Re: **Request for Access to Records under the Freedom of Information and Protection of Privacy Act (the "Act")**

**Copies of all Planning, Engineering and other staff reports that preceded the issuance of DP208380 and that contained conditions of issuing DP208380.  
Date range: January 1, 1988 to December 31, 1991.**

Re: Development Permit Application No. DPA 208380  
100 Terminal Avenue  
Portion of Lots C and 3, D.L.'s 196 & 2037, Plans 11511 & 15505

Your application was considered by the Development Permit Board at its meeting of September 18, 1989, and it was resolved to approve Development Permit Application No. 208380 as submitted, the plans and information forming a part thereof, thereby permitting the construction of a residential complex with buildings varying from 5 to 30 storeys, subject to the following conditions:

PROJECT FILE			
STATION SITE PHASE 1			
DRAWING BY			
GROUND FLOOR PLAN/ SITE PLAN (LOW-RISE)			
PROJECT NO.	8912	DATE	22 JUNE 05
DRAWN BY	CH CHOI	SCALE	1/8" = 1'-0"
CHECKED BY		DRAWING NO. C.P. 0003	
APPROVED BY		A 11

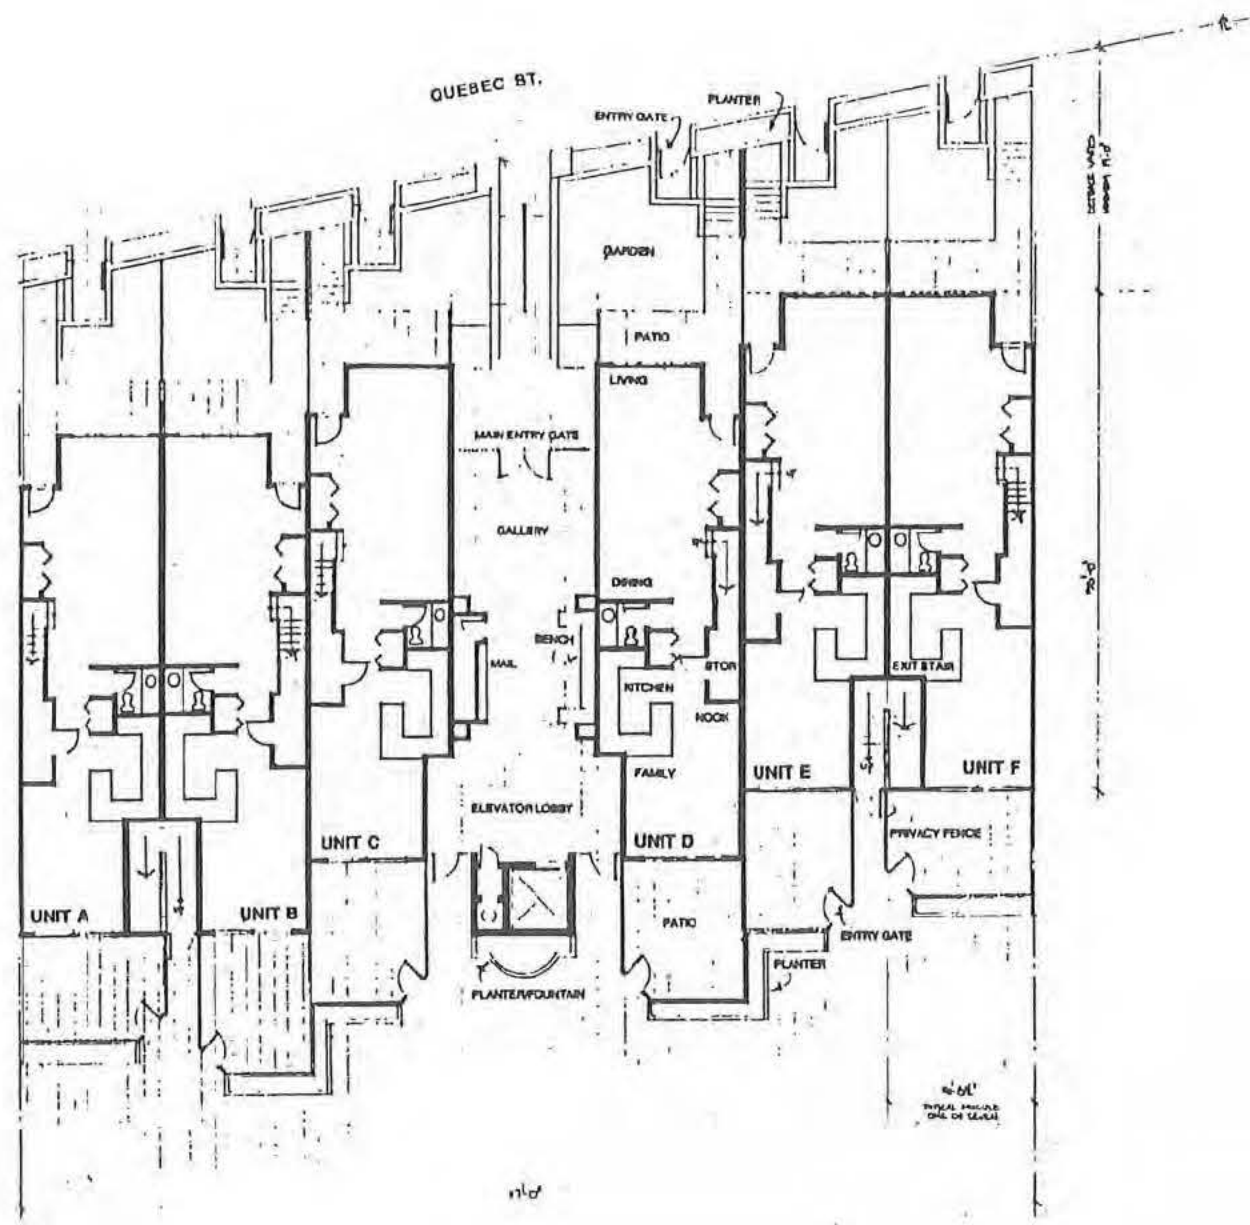
- 1.a.(i) *relocation of vehicular access/garage ramp from Thornton Place;  
(Note to Applicant: Vehicular access is to reflect arrangement as  
per revised drawings submitted on August 29, 1989.)*

the vehicular access/garage ramps and motor court have been deleted. The revised vehicular access/garage ramp is now located to the north of the proposed tower as shown on the revised drawings.

- the gas meters will be located recessed into the wall along the vehicular access/garage entry (as identified on the ground floor plan, Dwg. A3).
